PUBLIC HEALTH DIVISION
Drinking Water Services

Re: **Pacific Rim Apartments (PR#15-2018)**
City of Warrenton (PWS ID#00932)
Conditional Approval

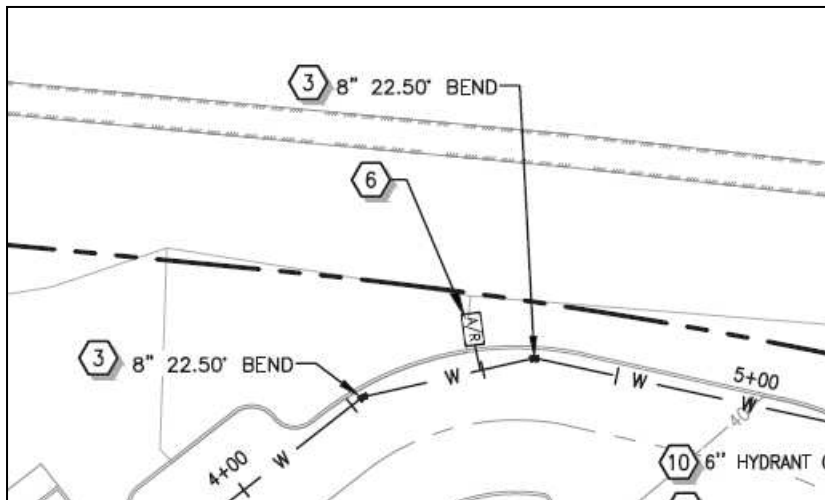
1. The City of Warrenton must indicate that the project conforms to the City's Comprehensive Plan (if applicable) or with the Statewide Planning Goals as required under OAR 660-031-0025. Although signed, whoever signed in section b. did not indicate if the project "IS or "IS NOT" compatible with the City's Comprehensive Plan or Planning Goals as shown below:

b. I find that this project (circle one) IS or IS NOT compatible. Attach appropriate land use decision(s) 215.416 (8) or (9) or 227.173 (1) OR (2) or (3).		tible. is required in ORS -025 (2) or (3).
Signed _____ Date <u>1/31/18</u>	Title <u>CDD</u>
